Product/Process Change Notice (PCN)																
<input type="checkbox"/> Major Change <input checked="" type="checkbox"/> Minor Change																
PCN Number: PCN_FrqSPXO_20250228 Affected Series: WE-SPXO Affected Part Number: See table below PCN Date: 2024-11-28 Effective Date: 2025-02-28	Change Category: <input type="checkbox"/> Equipment/Location <input checked="" type="checkbox"/> General Data <input type="checkbox"/> Material <input type="checkbox"/> Process <input type="checkbox"/> Product Design <input type="checkbox"/> Shipping/Packaging <input type="checkbox"/> Supplier <input type="checkbox"/> Software															
Contact: Product Management Phone: +49 (0) 7942 - 945 5001 Fax: +49 (0) 7942 - 945 5179 E-Mail: pcn.eisos@we-online.com	Datasheet Change: <input checked="" type="checkbox"/> Yes <input type="checkbox"/> No Attachment: <input type="checkbox"/> Yes <input checked="" type="checkbox"/> No															
DESCRIPTION OF CHANGE: <p>Because of a database mismatch, Würth Elektronik eiSos will correct the RoHs status (1), ageing (2), packaging details (3), IQD part number (4), drive capability (5), environmental parameters (6), product dimensions (7) and curren

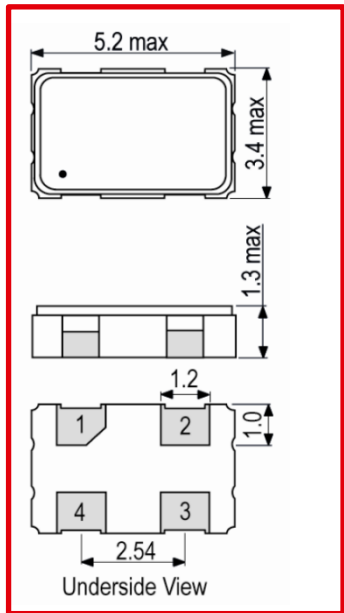
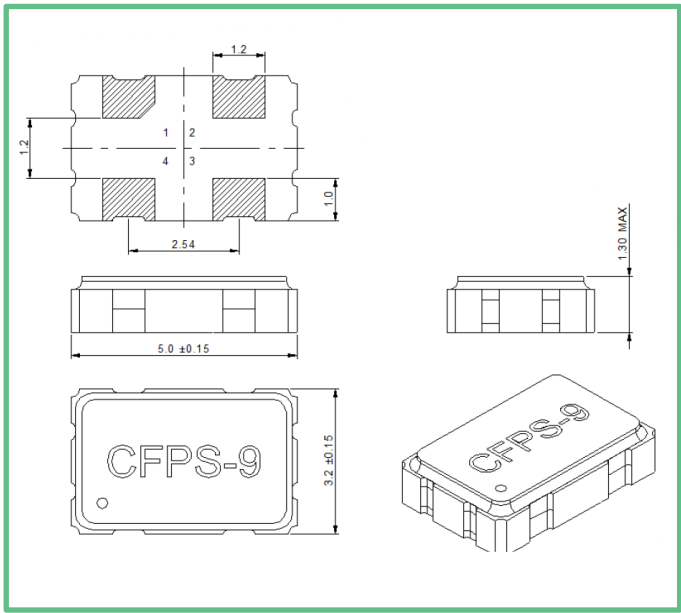
7. Correction of the Product Dimensions:

Before	After
Product Dimensions		
L	5.2 max	5.0 ± 0.15
W	3.4 max	3.2 ± 0.15
H	1.3 max	1.3 max
